RATIONALE

BOLT, MACHINE - DOUBLE HEXAGON EXTENDED
WASHER HEAD, PD SHANK, UNS S17400,
.1900-32 UNJF-3A

AS9732™
SHEET 1 OF 2

REV.
C

FIGURE 1 - BOLT

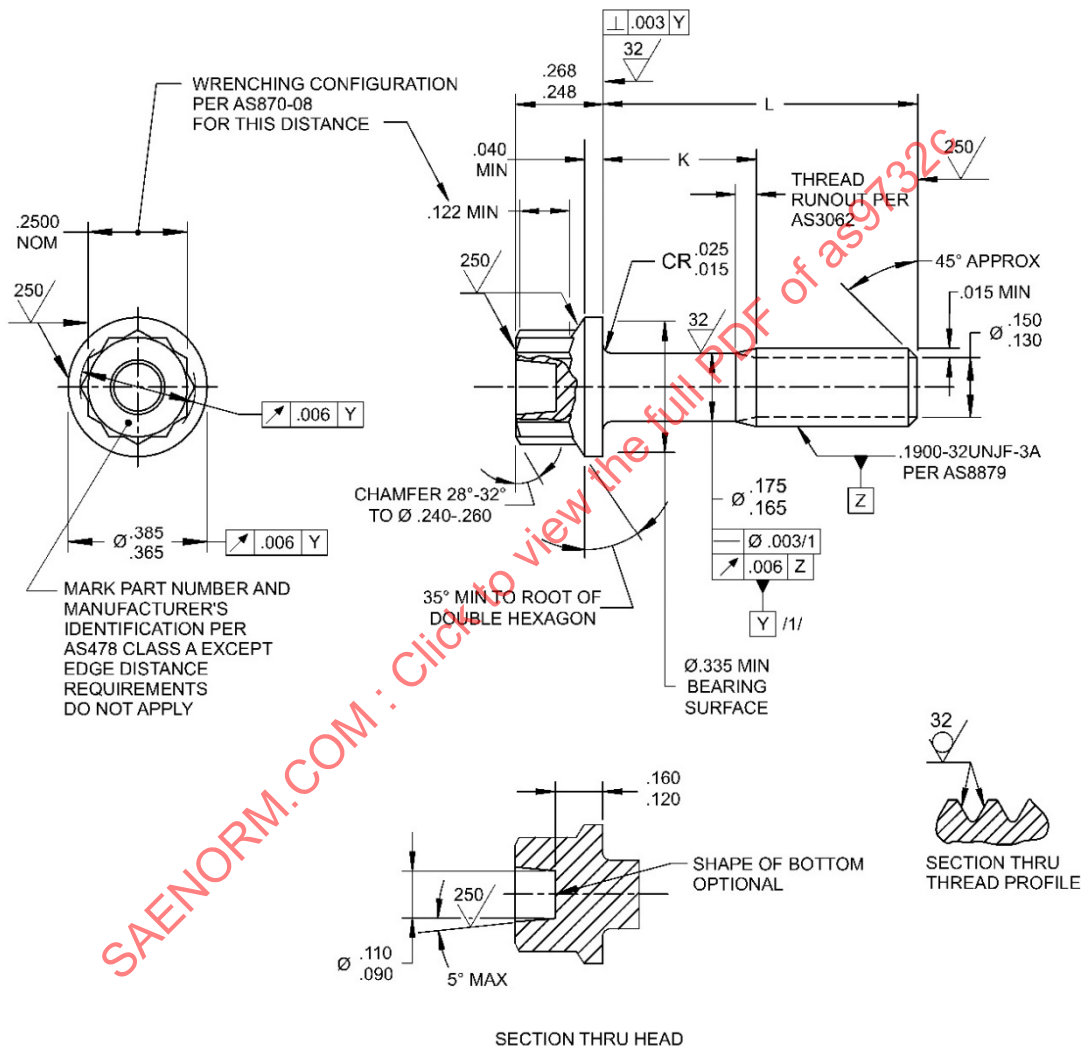
UPDATE TO ASME Y14.5-2018. REVISE LIGHTENING HOLE CONFIGURATION TO AS1132. REVISE FILLET RADIUS TO "CR." ADD UNS NUMBER TO NOTE 2. GENERAL EDITORIAL REVISIONS.
